Access Compliance Report

Public Rights-of-Way

(Curb Ramps)

Intersection ID: N/A	Main Street: TERRACE_DR	Cross Street: BOYCE_RD	Location: NW
ADA ID: EEFDB4A7FEA3	Ramp Type: Directional1	Initial Pass/Fail: Fail	Overall Compliance: No
Severity Score: 58.75			
Codes/Mitigation Info/Possible Solution		Field Measurements/Component Compliance

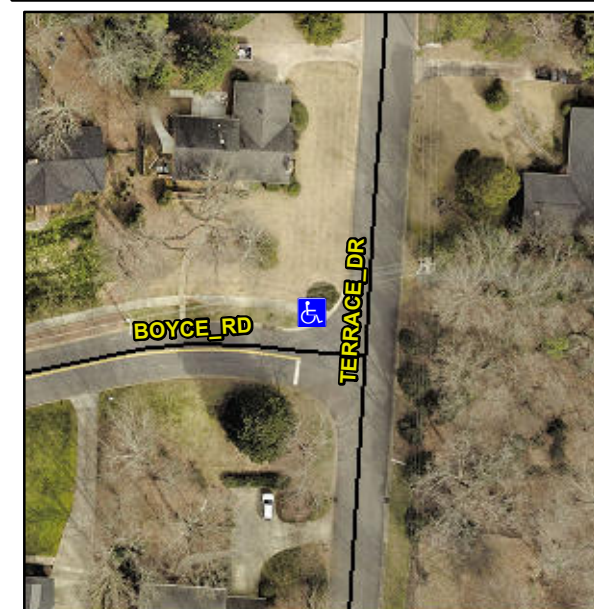
R304.5.1, R304.2.2, R304.5.3

Compliance	Description	Data	Compliance	Description	Data
N/A	Ramp Length (in)	86.0	N/A	Grade Break?	N/A
No	Ramp Width (in)	46.0	N/A	Grade Break Slope (%)	0.0
No	Ramp Slope (%)	12.4	N/A	Grade Break XSlope (%)	0.0
No	Ramp XSlope (%)	7.0			
N/A	Flare Type LT	N/A	N/A	Flare Type RT	N/A
N/A	Flare Slope LT (%)	N/A	N/A	Flare Slope RT (%)	0.0
N/A	Flare Traversable LT?	N/A	N/A	Flare Traversable RT?	N/A
N/A	Landing Length (in)	0.0	N/A	DWS Provided?	N/A
N/A	Landing Width (in)	0.0	N/A	DWS Contrast?	N/A
N/A	Landing Slope (%)	0.0	N/A	DWS Length (in)	N/A
N/A	Landing X Slope (%)	0.0	N/A	DWS Full Width?	N/A
N/A	Landing Curb? (Y/N)	N/A	N/A	DWS Offset LT (in)	N/A
N/A	Shared Landing?	N/A	N/A	DWS Offset RT (in)	N/A
N/A	Gutter Ponding?	0.0	N/A	Gutter Slope (%)	N/A
N/A	Gutter Lip Ht (in)	0.0	N/A	Gutter X Slope (%)	N/A
N/A	Painted X Walk1?	No		Road Slope (%)	4.8
	X Walk 1 Direction	To E		Road X Slope (%)	3.0
	X Walk 1 Width (in)	N/A		Clear Space?	N/A

X Walk 1 Slope (%)	4.8	N/A	Clear Space to XWalk (in)	N/A
	X Walk 1 X Slope (%)	3.0	N/A	Storm Grate/Utility Hazard?	N/A
N/A	Ramp inside XWalk1?	N/A		Storm Grate/Utility Type	
N/A	Any Obstructions?	N/A			N/A
	Obstruction Type		Yes	Surface Condition? (G/P)	Good
			N/A	Curb Slope (%)	10.9

Remove & Replace Entire Ramp.
